FILE NUMBER: PLN23-144

SUBJECT: Grading Approval and Design Review for a new single-family residence with Accessory Dwelling Unit (ADU) & Junior Accessory Dwelling Unit (JADU).

SITE LOCATION: 2425 Old Calaveras Rd, Milpitas (APN: 029-34-004)

RESPONSES TO INCOMPLETE LETTER – 1.

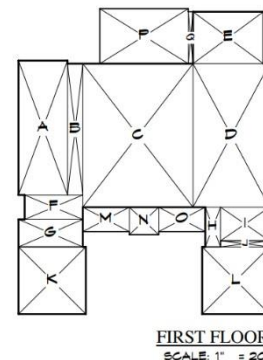
- Provide details of all proposed retaining walls, including the length and height of each wall, and top/bottom of wall elevations.

Response: The plan set has been revised to incorporate the display of Retaining Wall profiles, showcasing the length, height, and top/bottom of wall elevations. Please refer to Sheet C2.3 for detailed information.
